UNITED STATES PATENT AND TRADEMARK OFFICE

APPLICATION NO.	FILING DATE	FIRST NAMED INVENTOR	ATTORNEY DOCKET NO.	CONFIRMATION NO.
10/784,544	02/23/2004	George Athanasios Aggidis	04-40092-US	7766
7066	7590	03/13/2006	EXAMINER	
REED SMITH LLP 2500 ONE LIBERTY PLACE 1650 MARKET STREET PHILADELPHIA, PA 19103			EDGAR, RICHARD A	
			ART UNIT	PAPER NUMBER
			3745

Office Action Summary

DETAILED ACTION

Figure 1

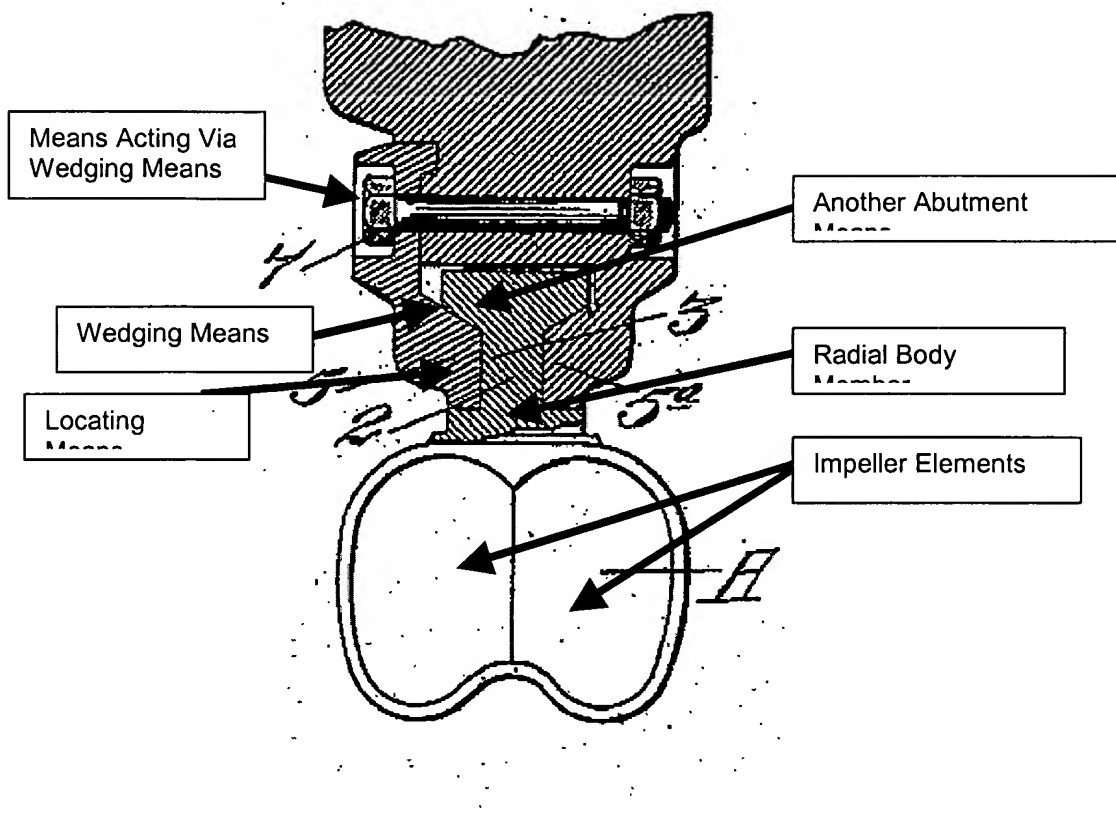
Claims 1-3, 5, 7-9, 11-17, 19-22 are rejected under 35 U.S.C. 102(b) as being anticipated by United States Patent No. 924,544 (Eckart hereinafter).

Eckart shows a turbine rotor having an axis of rotation, the wheel inherently mounted on an axle, a plurality of individual radial body members (see FIG. 3) carrying more than one integral impeller elements, and wherein the plurality of radial body members are secured to the wheel; each radial body member having leading and trailing radial abutment surfaces (see FIG. 2) relative to the rotation direction of the rotor that contact with the respective radial abutment surfaces of adjacent radial body members, each radial body member further comprising another abutment means (see FIG. 4), the turbine rotor further comprising locating means in engagement with the another abutment means, and wedging means which is tapered in the radial direction relative to the rotation axis and which acts between the abutment means and the locating means, and further comprising means acting via said wedging means to draw the radial body members radially inwards resisted only by contact of the respective adjacent leading and trailing radial abutment surfaces of the body members. See Figure 1 below.
